Fort Bliss Waste Sites and Potential Human Health Impacts at Proposed Migrant Detention Center

AUTHOR: JAMES BRINKMAN RPG

This report reviews documents obtained through Freedom of Information Act (FOIA) requests to the U.S. Army, including emails from the U.S. Army and Department of Homeland Security and various Comprehensive Environmental Response, Compensation, and Liability Act (CERCLA) and Resource Conservation and Recovery Act (RCRA) documents addressing Fort Bliss contaminated sites. This report also reviews documents from the Texas Commission on Environmental Quality (TCEQ).

Figure 1: Proposed Areas for Migrant Housing

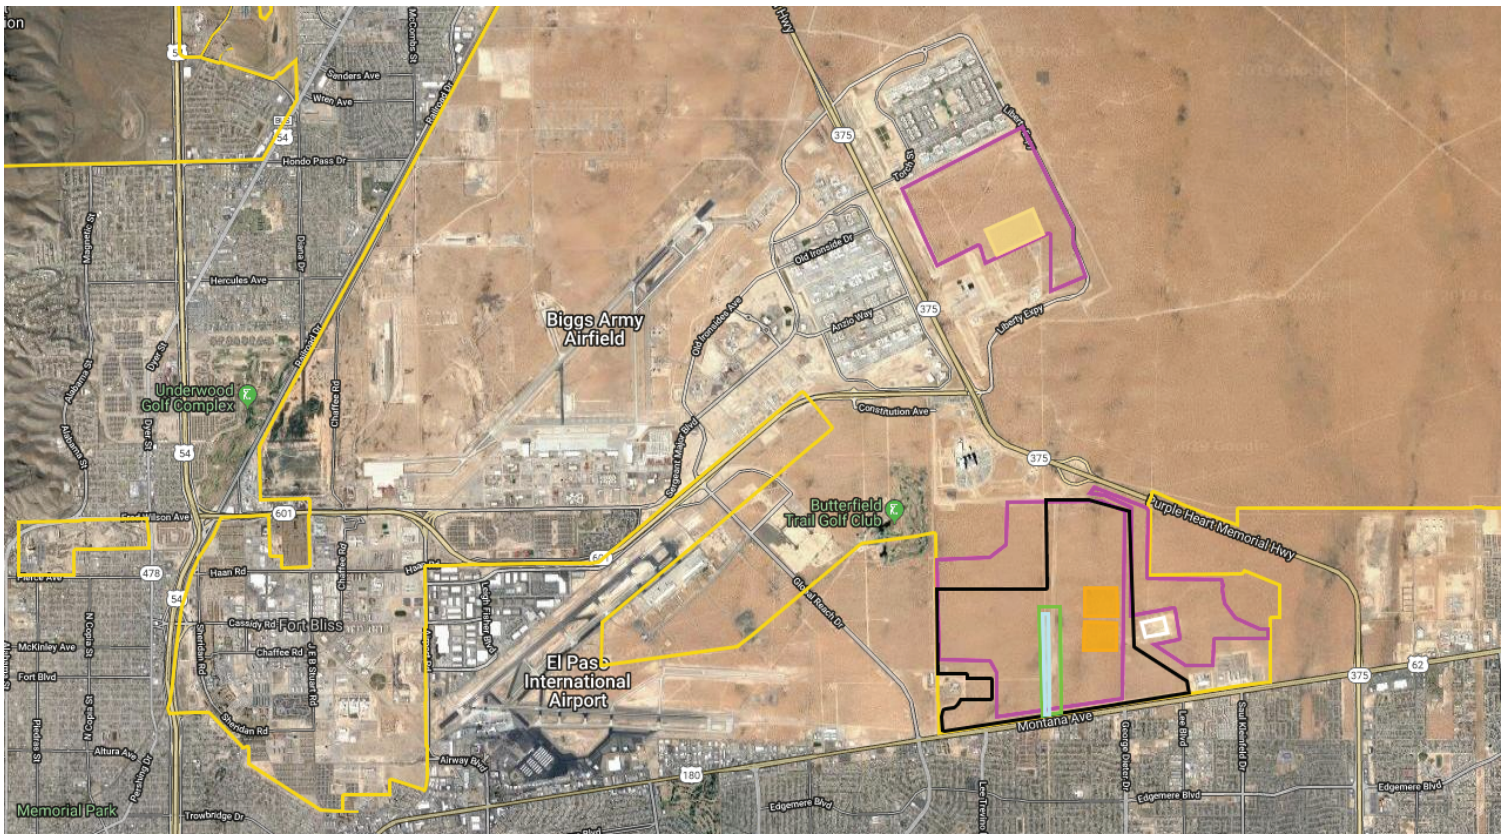
- The area currently proposed for the housing, "Parcel 2," contains one of these RCRA contaminated sites: an illegal dump and spill site known as the Rubble Dump and Spill Site or simply the Rubble Dump Site. The most recent emails from the FOIA request indicate that the Army plans to build detention center housing only 2,000 feet from this illegal dump. However, the detention center location was not finalized as of the FOIA request, and the final location of the detention center may include the contaminated dump and spill site. See FIGURE 1.

This is cause for concern because one of the base's contaminated sites, the Rubble Dump Spill Site (SWMU-16), is within Parcel 2. The final location for the detention center might be in or near this hazardous waste site.

In sum, the dump and spill areas were not fully characterized, and cleanup was not fully validated. Unauthorized and illegal vehicle entry has not been controlled in the area. Additional illegal dumping and spills could have occurred. Therefore, sampling and characterization of soil, soil gas, and ambient air must be completed, and the area must be deemed safe before the temporary migrant housing for children can be constructed.
